Status ~~2 - Disposition Needed~~ **Trend** 01-Deviation From Doc/Proc
Department NCSX **Division** WBS 123
Source/Org FABRICATION, OPERATIONS & MAINTENANCE
Item Dwg/Part# SE121-008 R1 **Procurement #** _____ **Cost Center** _____
RAP# 3268 **Job Doc #** D-NCSX-FPA-001 **Vendor** _____
RAP Title Field Period Assembly Station One

VVSA-1, On vacuum vessel sub-assembly #1 there are dimensional deviations with the placement of the heating and cooling lines, see below.

Deviation #1 (Pictures 1 & 2) – 8” max spacing between tube runs.

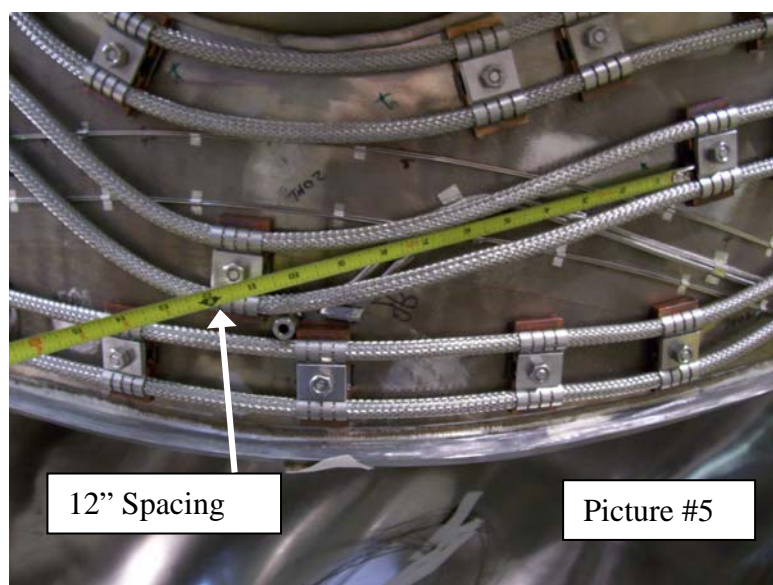
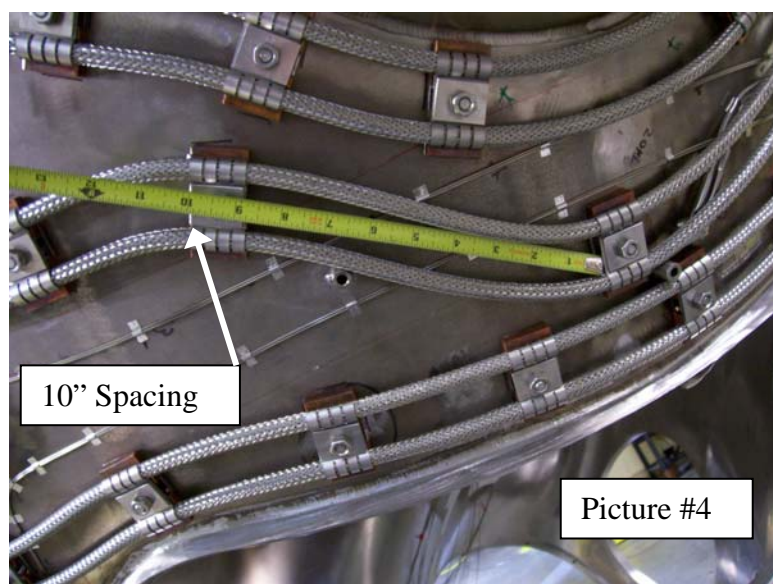
Deviation #1 - Drawing SE121-008 R1 page 1 of 5 detail A states "Spacing between tubing runs to not exceed 8" max." See attached pictures 1 & 2.

These wide spaces were known and would have been corrected by serpentine, asymmetric mounts but a decision was made not to fabricate them and just live with the less than even heating/cooling.
Paul

Deviation #2 (Pictures 3 thru 6) – 6” max spacing between H/C mounting studs.

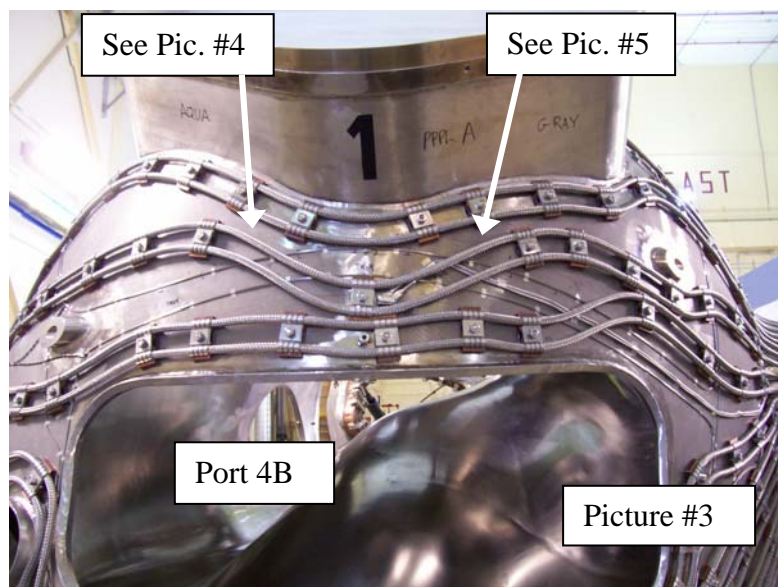
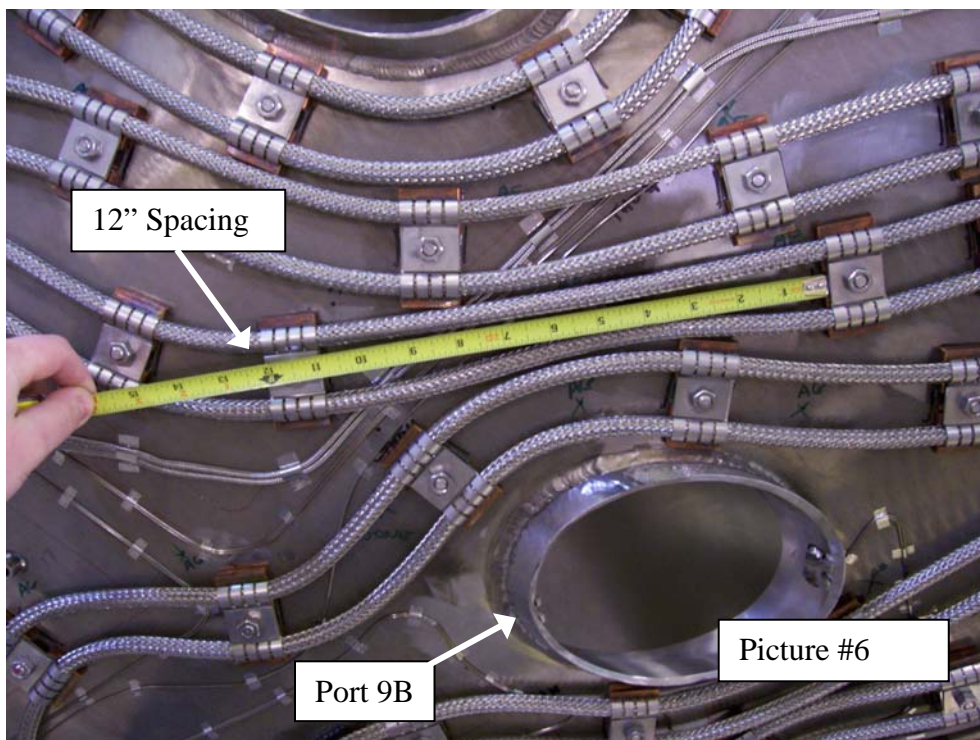
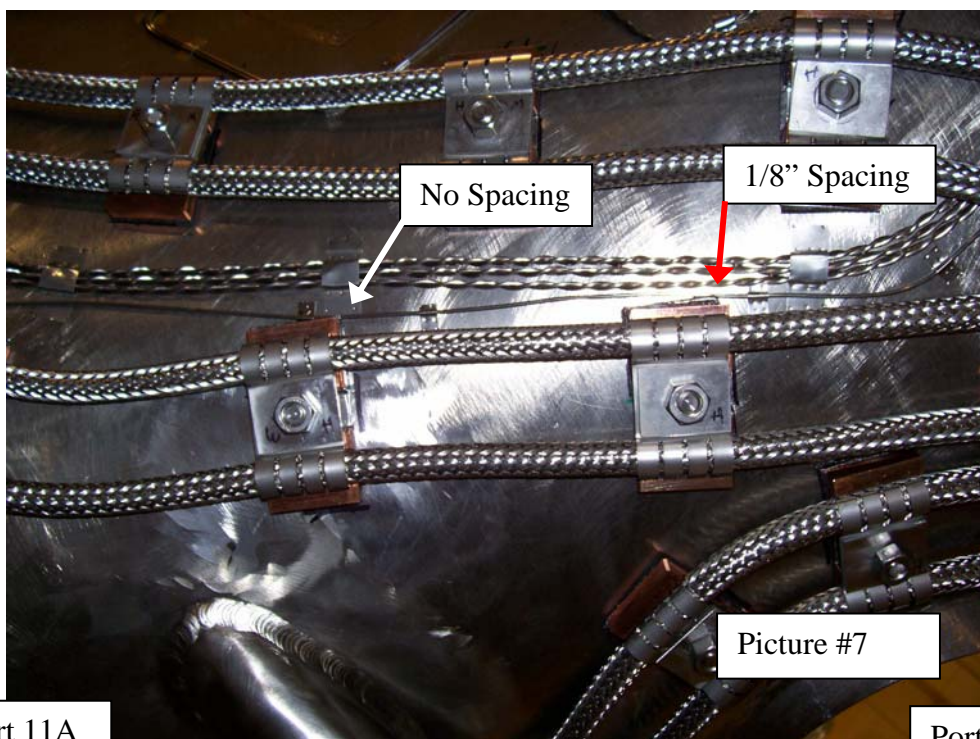
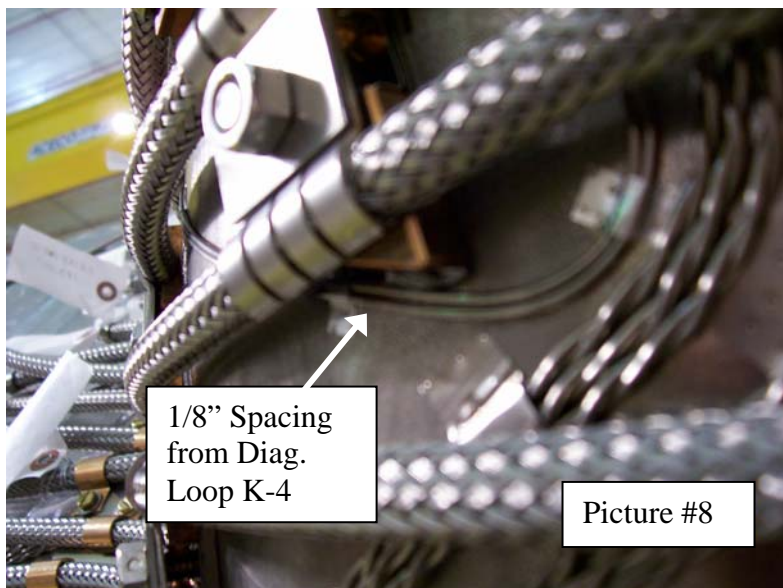
Deviation #2 - Procedure D-NCSX-FPA-001 R1 paragraph 6.7.1 calls for a 5" spacing between H/C stud locations with a tolerance of +/- 1" along the length of the hose. See attached pictures 3 thru 6.

Deviation #3 (Pictures 7 thru 10) – H/C saddle footprint a minimum of ¼” from flux loops.

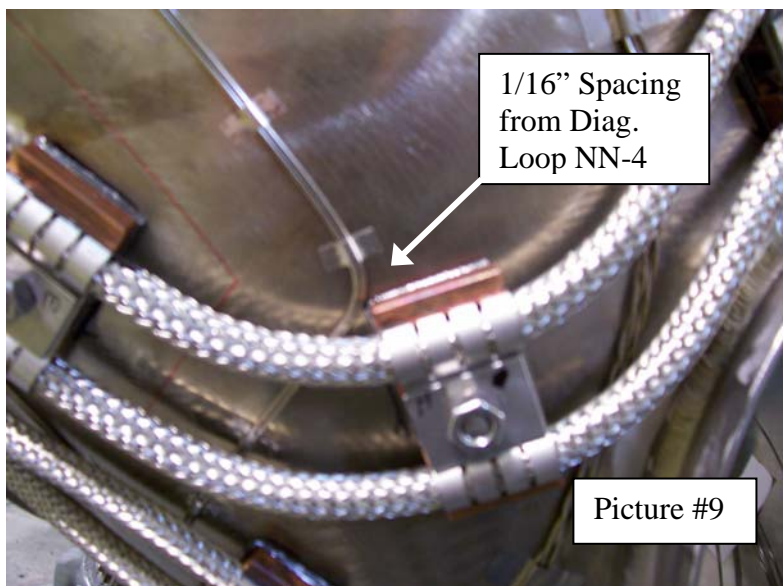
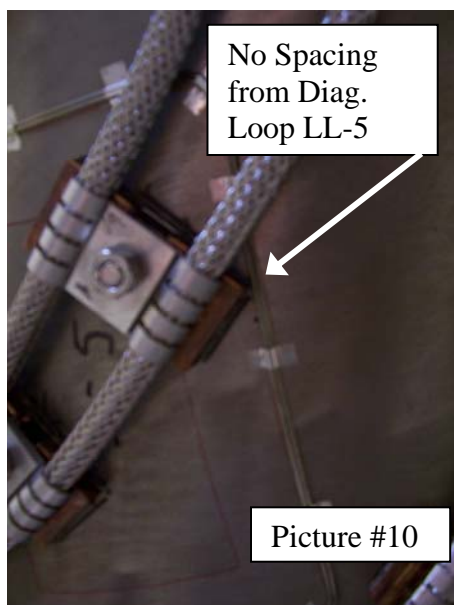
Deviation #3 - Procedure D-NCSX-FPA-001 R1 paragraph 6.7.2 states "Use heating cooling tube saddle foot print as a guide to maintain a minimum distance of 1/4 inch from the flux loops." See attached pictures 7 thru 10.
